Bid Bulletin #02

PROJECT: Skinner Early Childhood Center
Bid Package #4
Omaha, NE

ADDENDUM F

Skinner Early Childhood Center
Omaha, Nebraska
RDG Project No. 2014.128.00, File 35.1

D1 STEEL SECURITY BOLLARD

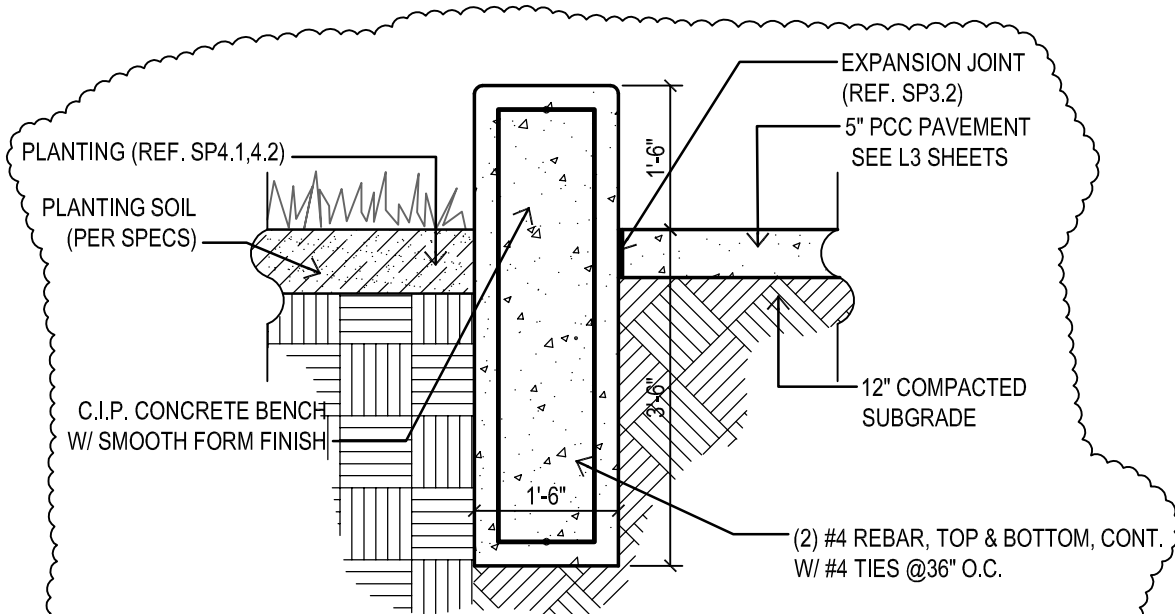
FLD-2 Sheet L5.01: Updated Detail D1 per attached Supplemental Drawing SDL-001.

SDL-003

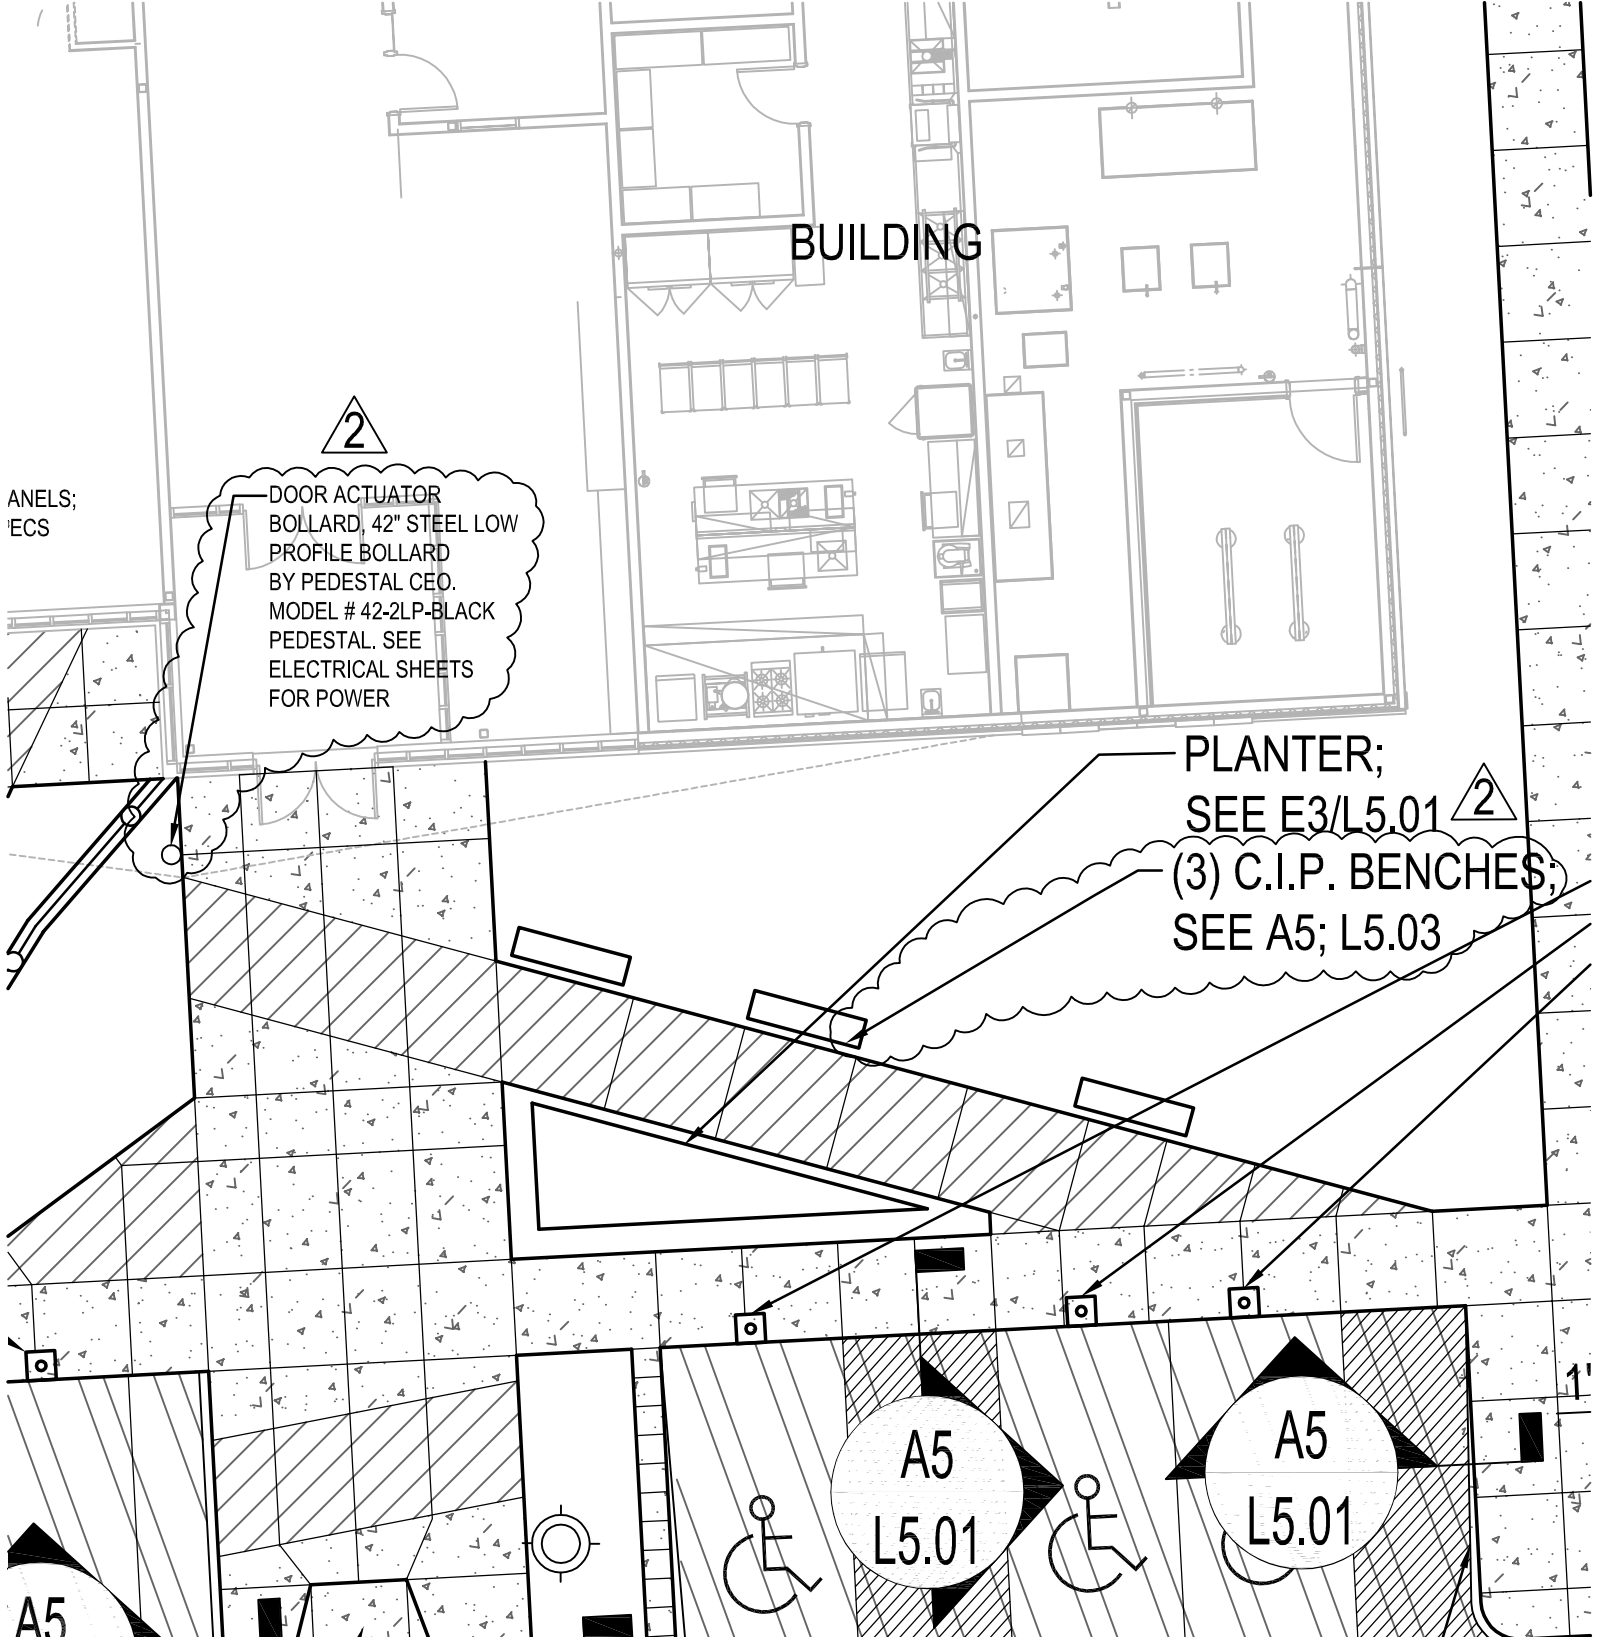
FLD-1 Sheets L3.01 and L3.02: Added actuator bollard at front entrance. Updated reference text for C.I.P benches at front entry. See attached Supplemental Drawing SDL-003.

DOOR ACTUATOR
BOLLARD, 42" STEEL LOW
PROFILE BOLLARD
BY PEDESTAL CEO.
MODEL # 42-2LP-BLACK
PEDESTAL. SEE
ELECTRICAL SHEETS
FOR POWER

PLANTER;
SEE E3/L5.01 2
(3) C.I.P. BENCHES;
SEE A5; L5.03
